TFL Pre-Application Discussions

As noted in the design development section of the D&A, discussions with TFL have been undertaken between May - July 2022 in which a number of key design issues were highlighted by the LU Engineer. Subsequently these issues have been addressed and the following sections identify what measures have been incorporated into the design to mitigate the issues raised.

Proposed new mixed used development, Pinner Road, Northwood, London, HA6 1DD

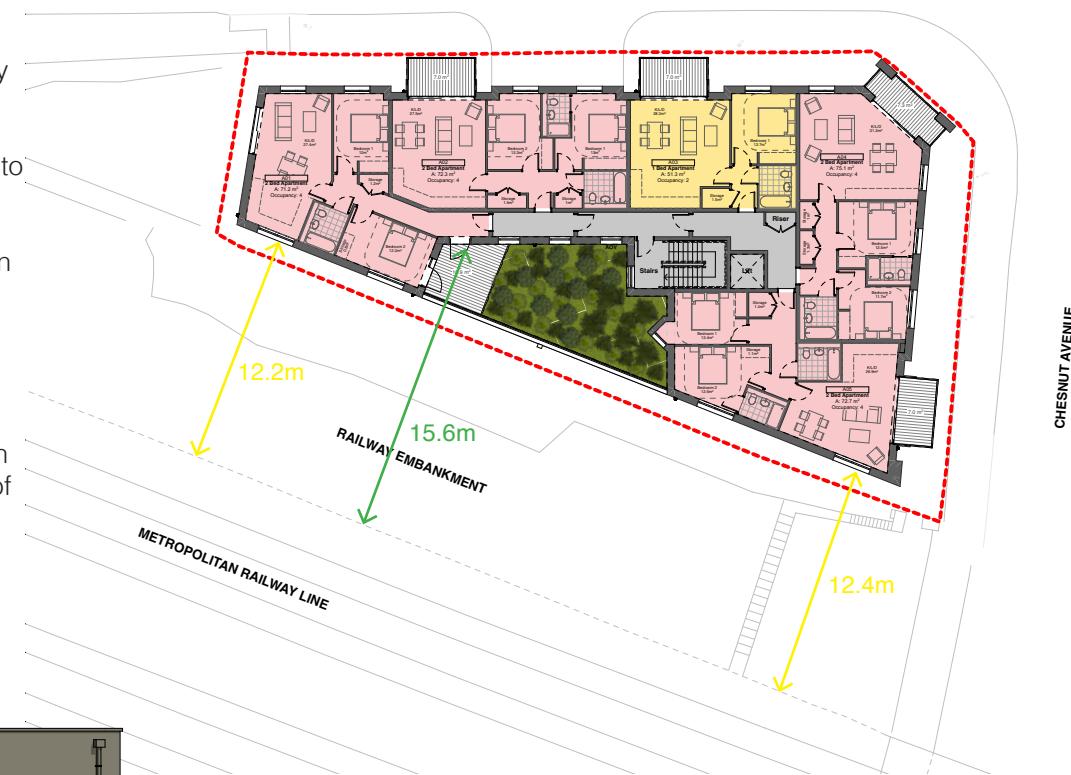
TFL Pre-Application Discussions - Proximity of Openable Windows

Whilst there is no specific guidance from TFL in regard to openable windows and their proximity to the railway, consideration has been given to this where windows are immediately overlooking the TFL boundary and any potential nuisances arising from fully openable windows in this location.

As seen in the adjacent first floor plan the distance from the top of railway embankment to the nearest window is approximately 12.2m.

Windows with restrictors (max 100mm opening) are proposed to the Southwest Elevation facing towards the railway (highlighted yellow on the below proposed southwest elevation) to limit the potential for rubbish being thrown onto the TFL access route adjacent the Southwest boundary.

Other openable windows facing in this direction are set further back from the TFL boundary looking over the first and second floor landscaped terraces (highlighted green on the below elevation), with the closest openable window being 14.3m away from top of railway embankment and the remainder tapering away further still.

Proposed Section

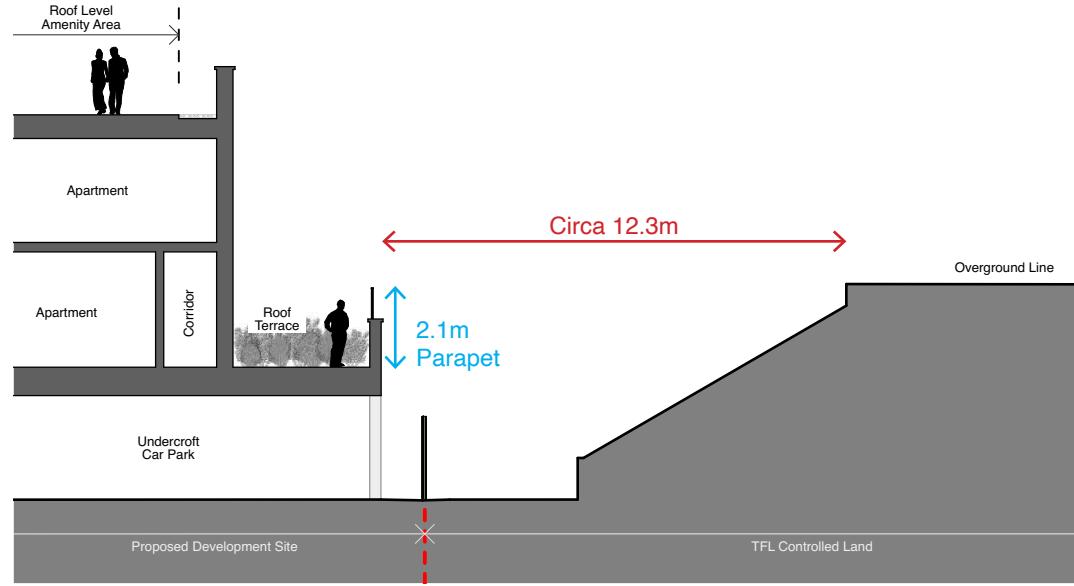
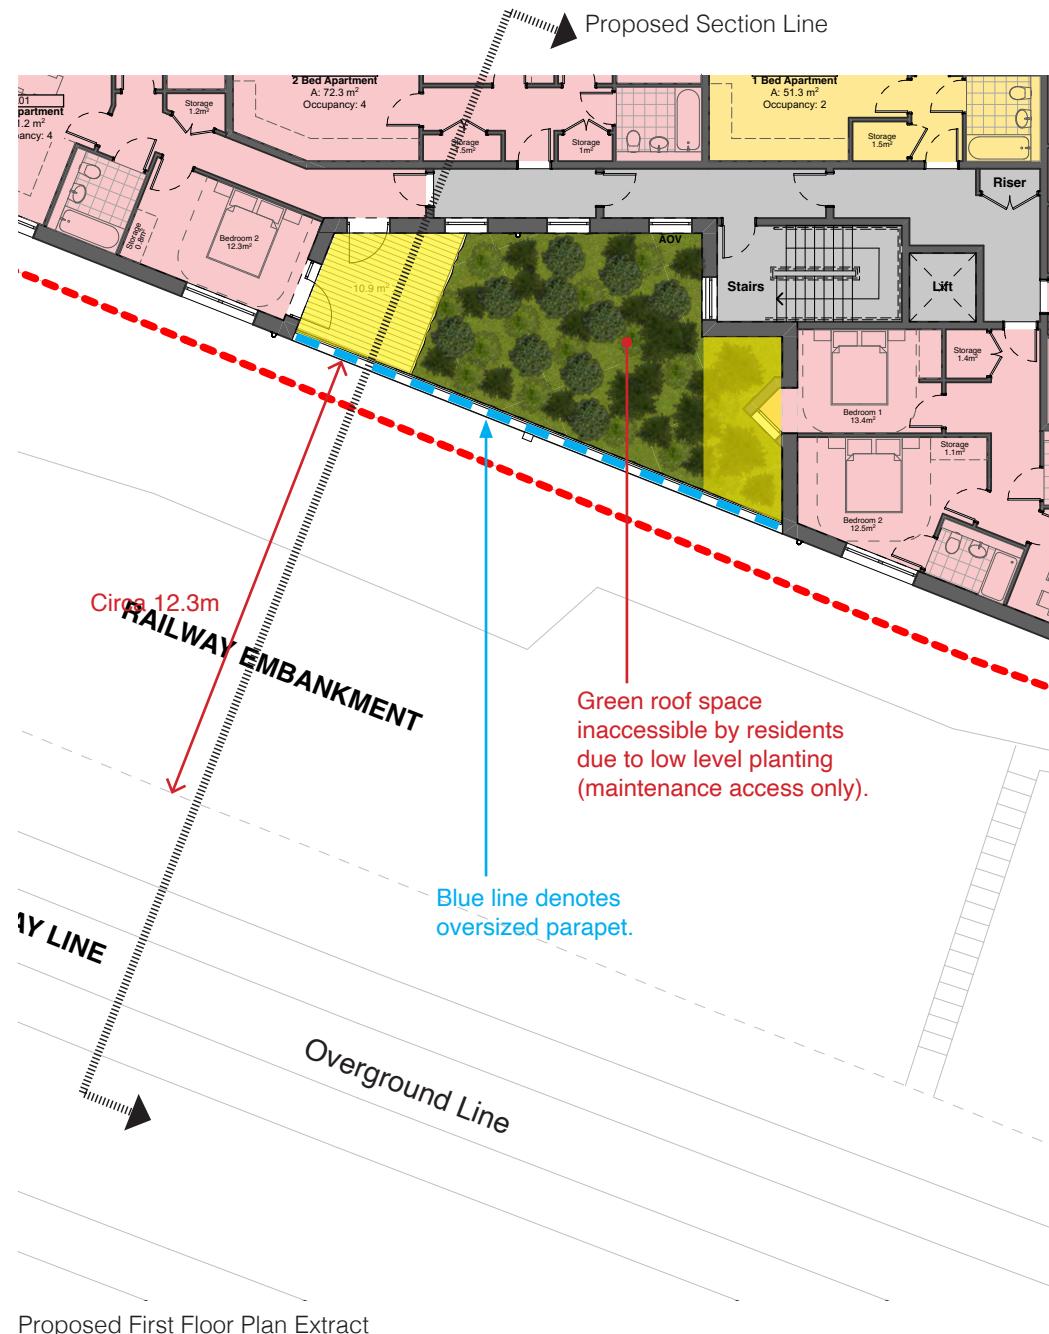
TFL Pre-Application Discussions - Proximity of Balconies and Roof Terraces

Whilst there is no specific guidance from TFL on the acceptable distances of balconies or roof terraces to the railway, consideration has been given to this concern raised by the LU engineer.

Roof terraces are proposed at first floor level to meet the requirements of the London Housing Design Guide and provide at least the minimum areas of private amenity space for the proposed dwellings. The small terraces at first floor level are facing into the development and do not face towards the railway (highlighted yellow on the adjacent plan), however they do flank the parapets on their shortest sides that face over TFL boundary and towards the railway. We are therefore proposing to provide larger than standard parapet heights to these terraces (see section below) consisting of part solid parapet wall with glazed balustrade above to create a solid barrier to the Southwest Elevation. The total height of the parapet and balustrade will be circa 2.1m high (equivalent to a tall boundary fence) and glazing to the balustrade will be anti-glare as described previously.

Furthermore it can be seen adjacent and below that there is considerable distance between these terraces and the top of the railway embankment which also resides at a higher level than the terrace.

Proposed Second Floor Plan Extract

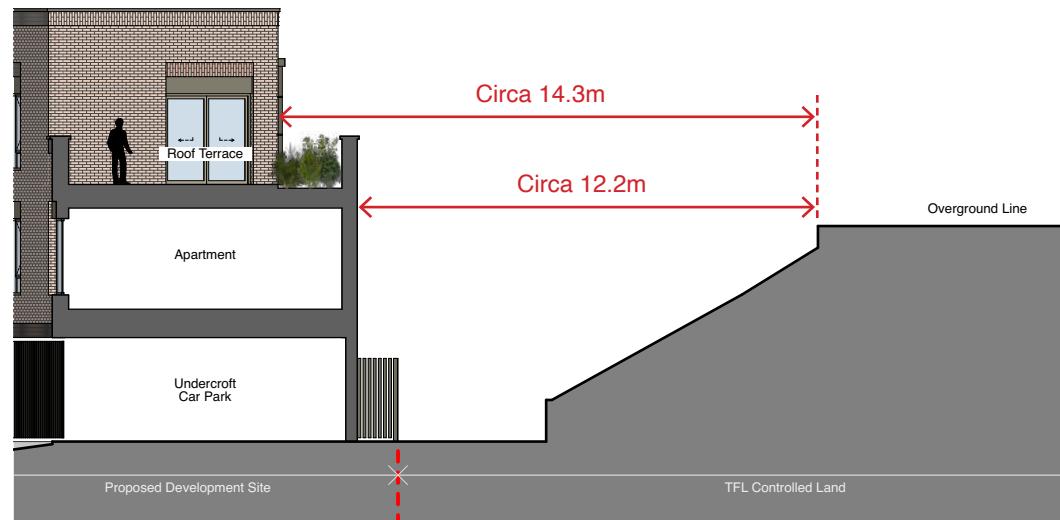
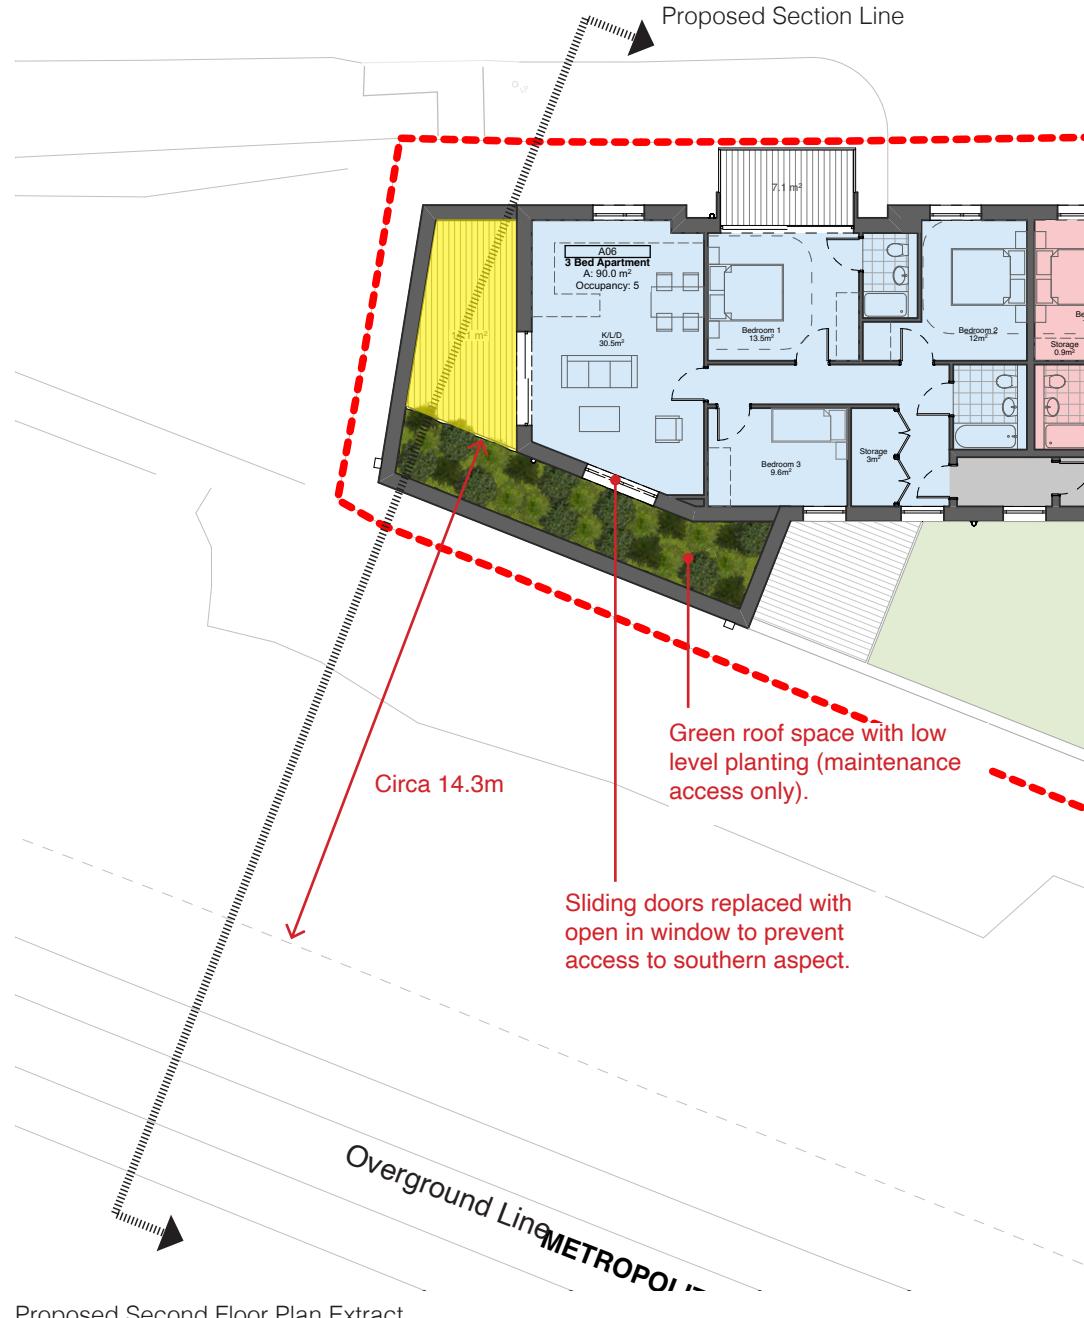
TFL Pre-Application Discussions - Proximity of Balconies and Roof Terraces

A roof terrace is proposed at second floor level to meet the requirements of the London Housing Design Guide and provide at least the minimum area of private amenity space for the proposed dwelling. The terrace at second floor level (highlighted yellow on the adjacent plan) previously faced towards the railway (May 22 proposals). The design has developed allowing for a green roof space with low level planting to prevent residents from being able to access the roof space facing towards the railway, however intermittent maintenance will be required. Doors previously facing towards the railway and accessing the now removed southwest facing section of the terrace have been replaced with open in windows to allow for cleaning.

Furthermore it can be seen adjacent and below that there is considerable distance between this terraces and the top of the railway embankment.

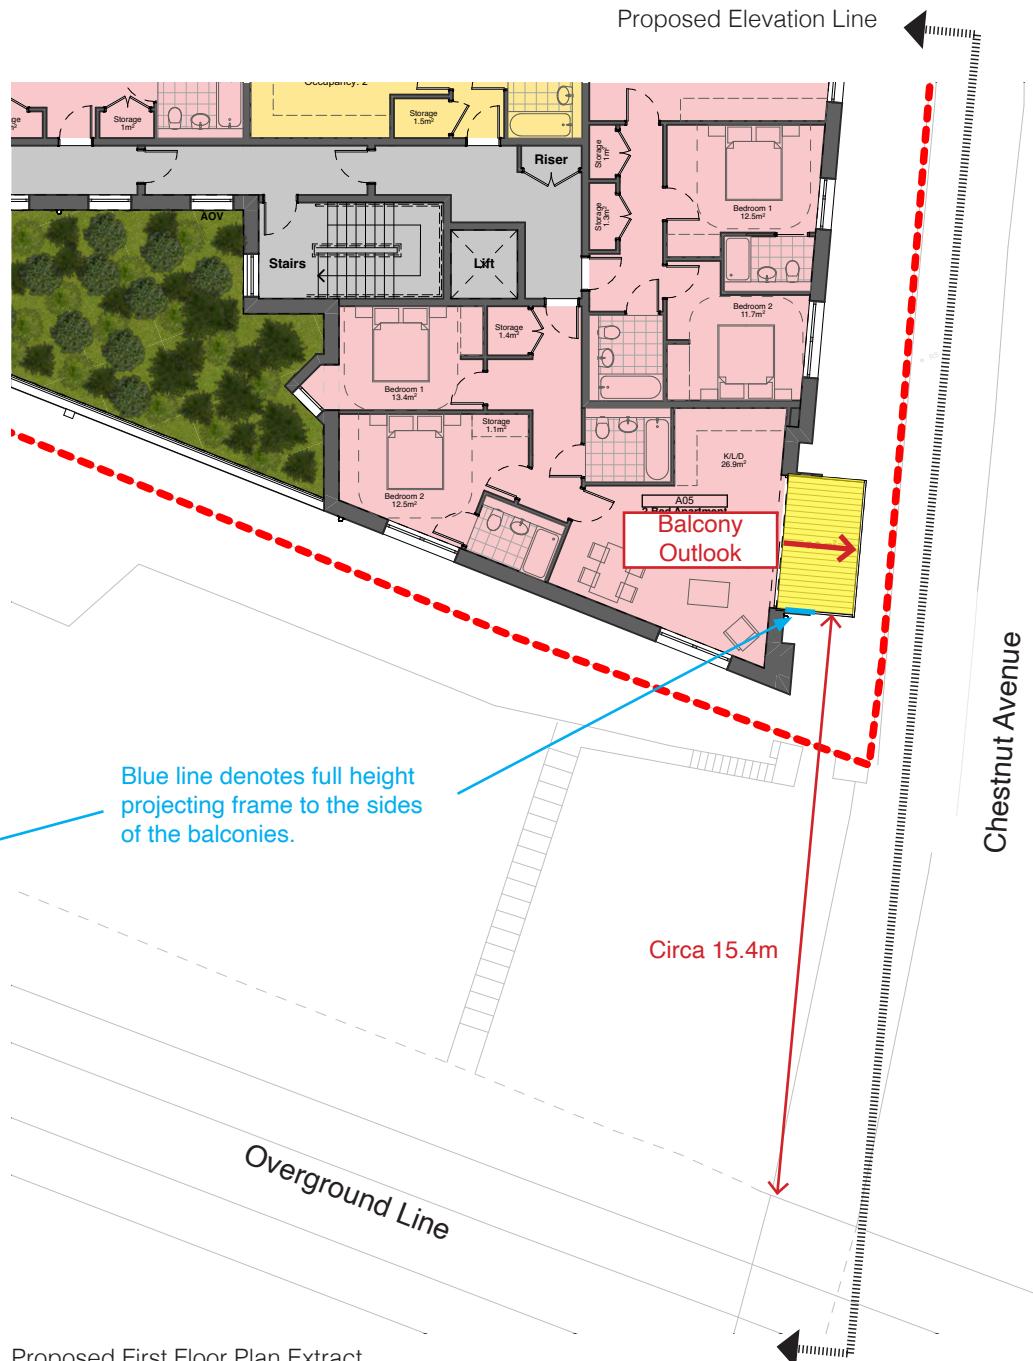
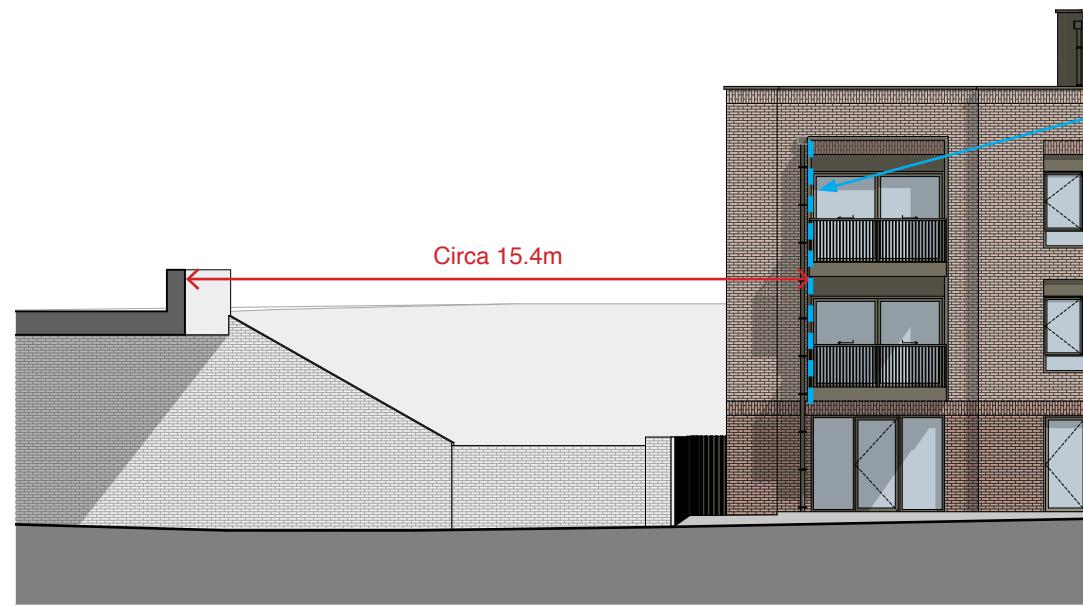
TFL Pre-Application Discussions - Proximity of Balconies and Roof Terraces (Continued)

Balconies are proposed at first floor and second floor level to meet the requirements of the London Housing Design Guide and provide at least the minimum areas of private amenity space for the proposed dwellings. The balconies at first and second floor level (position highlighted yellow on the adjacent plan) are facing onto Chestnut Avenue and do not face towards the railway, however to one side they are within a 3.5 meters of the TFL boundary but are a considerable distance away from the railway as can be seen in the images provided.

As well as being angled slightly away from the railway, the balconies are part-recessed into the facade with the addition of a part-depth full-height framing to the sides of the balconies which will limit outlook towards the railway.

Proposed Section A

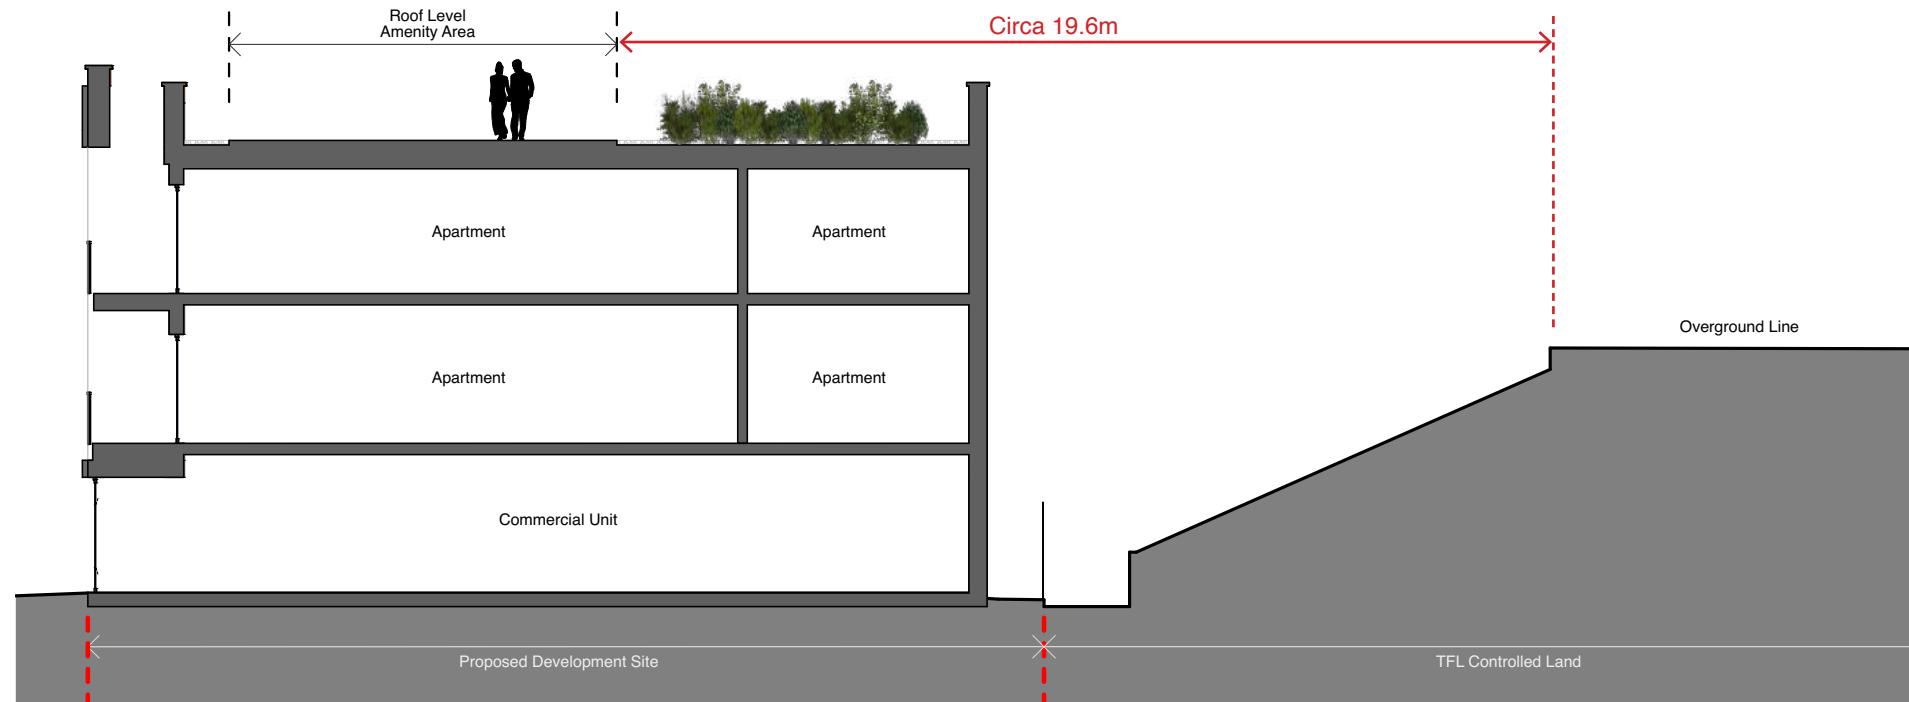
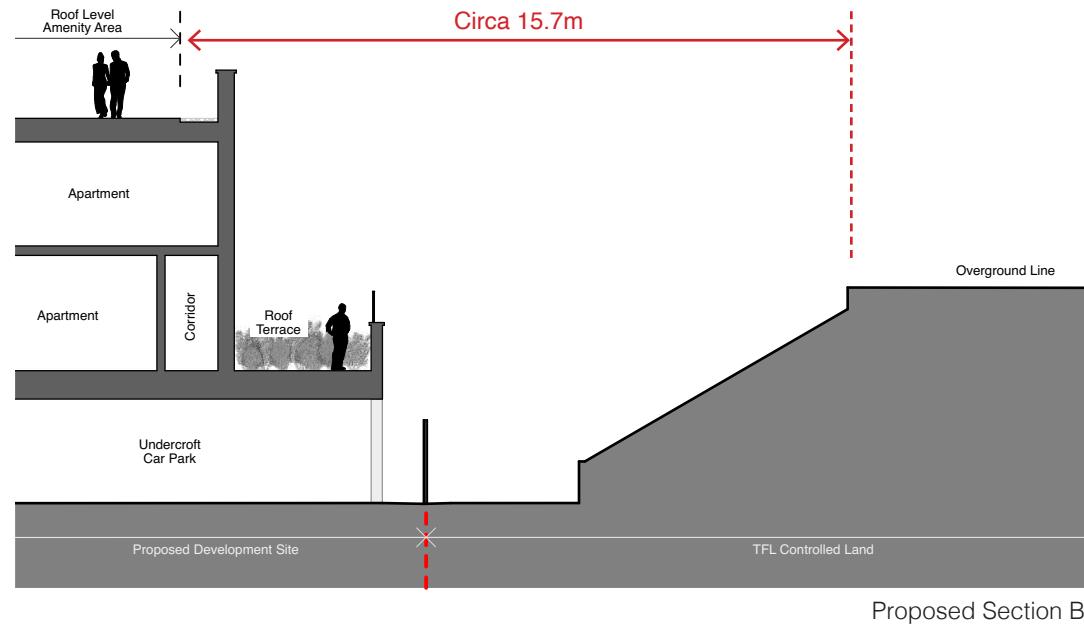
TFL Pre-Application Discussions - Proximity of Balconies and Roof Terraces (Continued)

The amenity space (highlighted yellow on the roof plan on the next page) has been redesigned to maximise the distance between accessible parts of the roof space and the railway as can be seen in the sections below/ adjacent and roof plan on the next page.

A planted area has been added to the roof that will prevent residents from being able to access the parts of the roof immediately adjacent the TFL boundary. In addition a perimeter of deterrent paving surrounding the accessible parts of the roof terrace act as a deterrent in accessing the edges of the roof.
